PALLADIAN SUBDIVISION

APPLICATION NUMBER 6 DATE January 22, 2004

REQUEST Subdivision

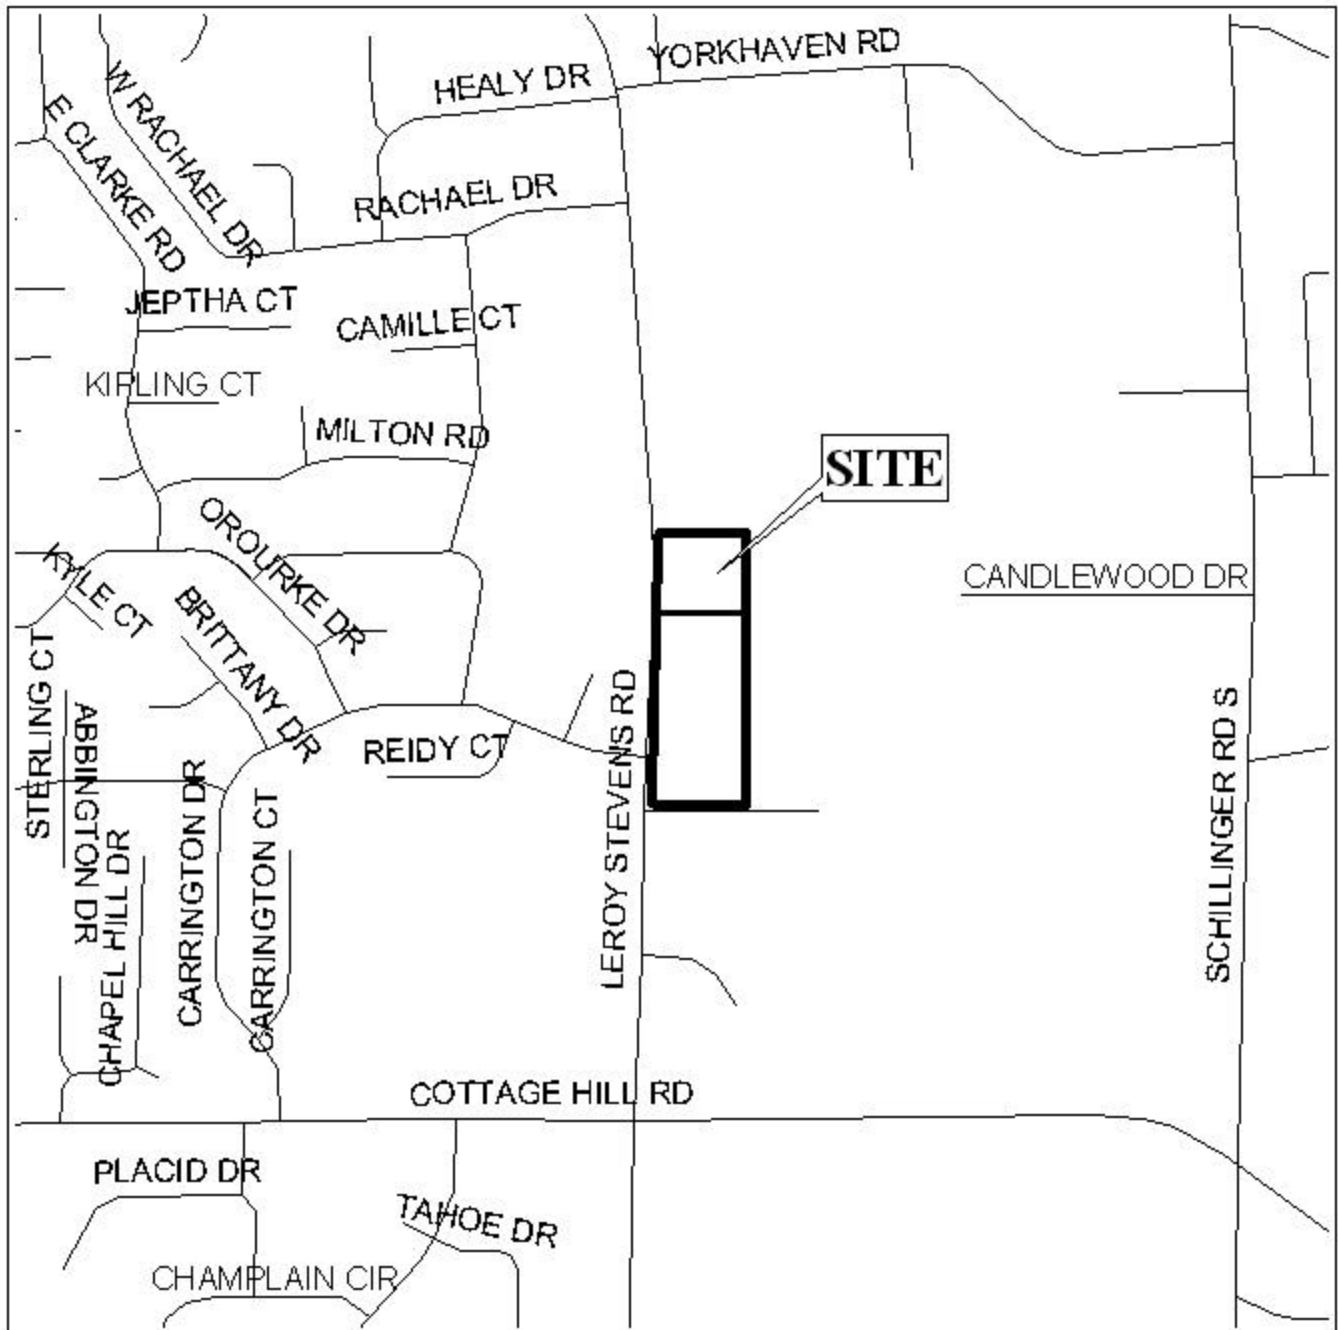
Engineering Comments: Must comply with the Mobile County Flood Damage Prevention Ordinance.

The purpose of this application is to shift an interior lot line.

As a means of access management, a note on the final plat stating that the size, number, location and design of all curb cuts to Leroy Stevens Road are to be approved by County Engineering should be required. Direct access to the park entrance road should be denied.

This site is located in the County, thus a note should be placed on the final plat stating that any lots which are developed commercially and adjoin residentially developed property must provide a buffer, in compliance with Section V.A.7. of the Subdivision Regulations.

With modifications, the proposed plat meets the minimum requirements of the Subdivision Regulations and is recommended for Tentative Approval subject to the following conditions: 1) the placement of a note on the final plat stating that the size, number, location and design of all curb cuts to Leroy Stevens Road are to be approved by County Engineering; 2) the placement of a note on the final plat stating that the site is denied direct access to the park entrance road; and 3) the placement of a note on the final plat stating that any lots which are developed commercially and adjoin residentially developed property must provide a buffer, in compliance with Section V.A.7. of the Subdivision Regulations.
